Access Compliance Report

Public Rights-of-Way

(Curb Ramps)

Intersection ID: 31185	Main Street: CARVER_POND_RD	Cross Street: CLOVERSIDE_LN	Location: SW
ADA ID: 61D5743AA0A3	Ramp Type: PerpDiag	Initial Pass/Fail: Fail	Overall Compliance: No
		Severity Score: 10

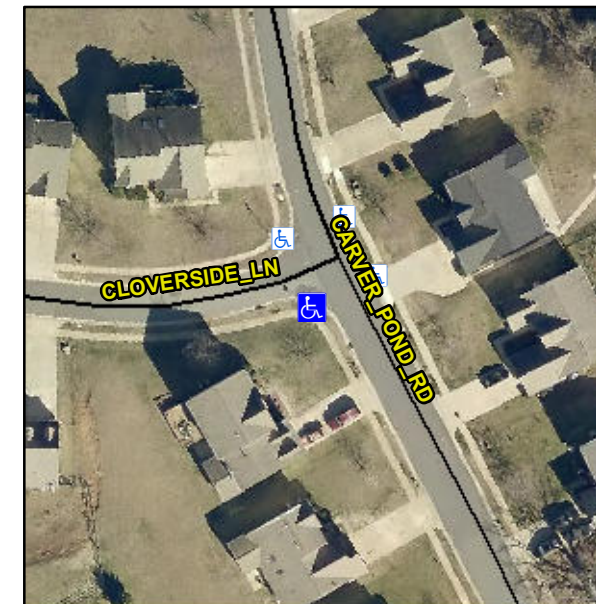
Not Found, R304.5.1, R304.5.3

Compliance	Description	Data	Compliance	Description	Data
N/A	Ramp Length (in)	54.0	Yes	Ramp Slope (%)	5.0
No	Ramp Width (in)	36.0	No	Ramp XSlope (%)	4.6
N/A	Flare Type LT	N/A	N/A	Flare Type RT	N/A
N/A	Flare Slope LT (%)	N/A	N/A	Flare Slope RT (%)	N/A
N/A	Flare Traversable LT?	N/A	N/A	Flare Traversable RT?	N/A
N/A	Landing Length (in)	N/A	N/A	DWS Provided?	N/A
N/A	Landing Width (in)	N/A	N/A	DWS Contrast?	N/A
N/A	Landing Slope (%)	N/A	N/A	DWS Length (in)	N/A
N/A	Landing X Slope (%)	N/A	N/A	DWS Full Width?	N/A
N/A	Landing Curb? (Y/N)	N/A	N/A	DWS Offset (in)	N/A
N/A	Shared Landing?	N/A			
N/A	Gutter Ponding?	N/A	N/A	Gutter Slope (%)	N/A
N/A	Gutter Lip Ht (in)	N/A	N/A	Gutter X Slope (%)	N/A
N/A	Painted X Walk1?	No	N/A	Painted X Walk2?	No
	X Walk 1 Direction	To E		X Walk 2 Direction	To N
N/A	X Walk 1 Width (in)	N/A	N/A	X Walk 2 Width (in)	N/A
	X Walk 1 Slope (%)	4.4		X Walk 2 Slope (%)	3.6
	X Walk 1 X Slope (%)	7.1		X Walk 2 X Slope (%)	0.7

Remove & Replace Curb Ramp With Two New Directional Ramps or Equivalent.
